**KNOXVILLE/KNOX COUNTY METROPOLITAN PLANNING COMMISSION
SUBDIVISION REPORT - CONCEPT**

▶ **FILE #:** 4-SA-12-C

▶ **SUBDIVISION:** CIRCLE LANE (ODAR FACILITY)

CONCEPT PLAN OF IMPROVEMENTS TO CIRCLE LANE
 KNOXVILLE, TENNESSEE 37919

CIRCLE DRIVE
 PLAN & PROFILE

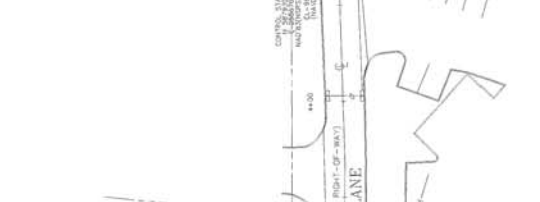
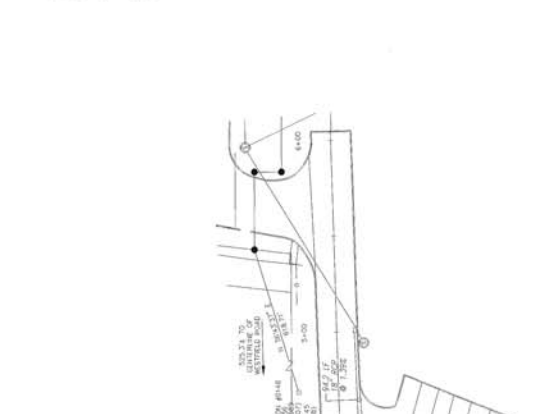
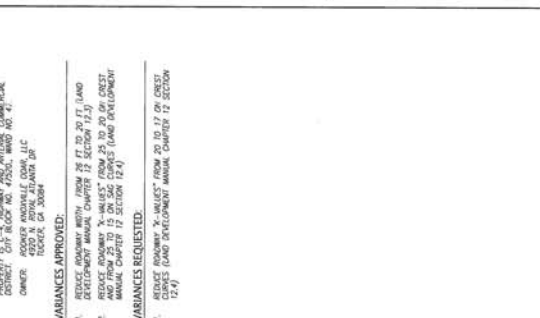
▶ **SUBDIVISION VARIANCES REQUIRED:** 1. Vertical curve variance from a K value of 25 to a K value of 17 on a crest

The applicant is revising a previously approved concept plan. Since the plan was originally approved, Circle Ln. has been extended. However, the extension was not exactly built as approved by MPC. The applicant is now requesting the needed variance to bring the plan in line with the construction. Staff does not object to this variance. The topography and the proximity to surrounding properties impacted how the road could actually be extended.

▶ **APPROVE variance 1 because the site's topography restricts compliance with the Subdivision Regulations, and the proposed variances will not create a traffic hazard.**

APPROVE the Concept Plan subject to 3 conditions:

1. Posting the speed limit on Circle Ln. at 25 mph as required by the Knoxville Engineering Dept.
2. Meeting all other applicable requirements of the Knoxville Engineering Dept.
3. A final plat application based on this concept plan will not be accepted for review by the MPC until certification of design plan approval has been submitted to the MPC staff.
